Ministry of the Environment,  
Conservation and Parks

Species at Risk Branch

April 7, 2022

## Comments on Undertaking # 18: GenPGM caribou connectivity analysis

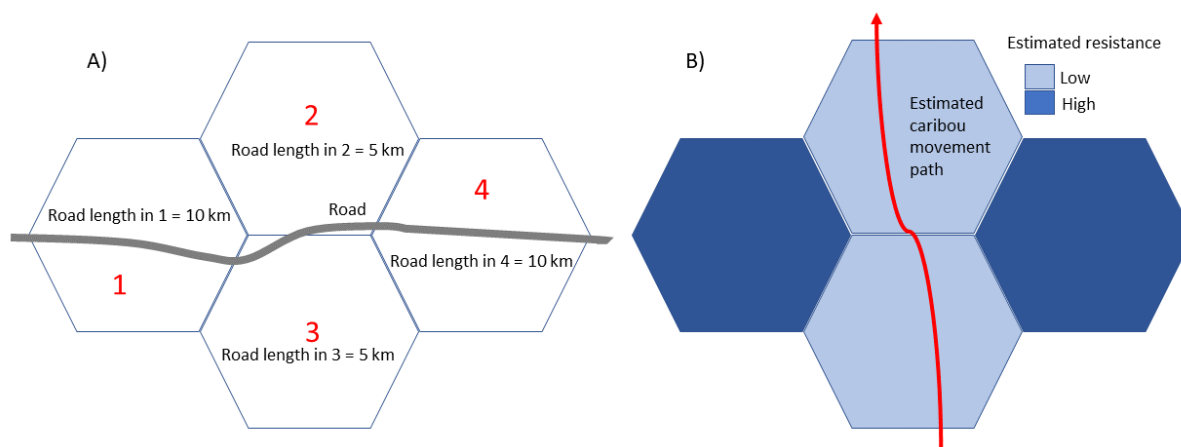
*Comment 2 of 12 January 2022. The importance of linear features is not recognized.* In my January comment, I noted that the semi-quantitative models involve accounting for the proportion of a hexagon occupied by linear features such as roads and rail lines. Linear features are also buffered by 4 to 22.5 m and this buffered area is included in the estimated proportion. This approach is analogous to estimating the density of linear features as a way to estimate their cost in a hexagon. I suggested the following thought experiment: Imagine a 10-m high chain-link fence erected through the middle of the study entire area, bisecting the eastern and western halves. This fence would be a complete barrier to caribou, but would only constitute a small proportion of any of the hexagons. A low cost would be estimated in this imaginary scenario using the proponent's 'semi-quantitative model', and low impact on connectivity would be inferred.

This comment from January was not addressed in Undertaking #18, and remains relevant. I now add the following observations. The proponents have used a multi-scale analysis, emphasizing that processes can be scale dependent. I would highlight that using their method of modelling linear features, the larger the hexagon, the less important the linear features will be to estimated connectivity. Thin, linear features are almost completely dissolved into large hexagons. Therefore, not surprisingly, there was no observed effect on estimated connectivity in the 5000 ha hexagons. This is not the same however, as their being no actual effect on connectivity. Imagine that thin fence running through a 5000-ha forest. The fence would be a small proportion of the 5000-ha area, but it would be a complete barrier nonetheless. The lack of an observed effect on connectivity at the larger scales of analysis is an artefact of the methods employed to estimate linear features.

Important linear features like roads should be over-imposed onto GIS layers (i.e., given priority in a pixel) for connectivity analyses. For this reason, connectivity analyses are generally not conducted at multiple scales. Instead, the analysis should be carried out at a high enough resolution that important landscape features (such as roads) are preserved in the landscape depiction. Linear features should be given priority in a raster and represented seamlessly in connectivity maps. Otherwise, it will appear that gaps in the linear features exist where there are none (Fig. 1).
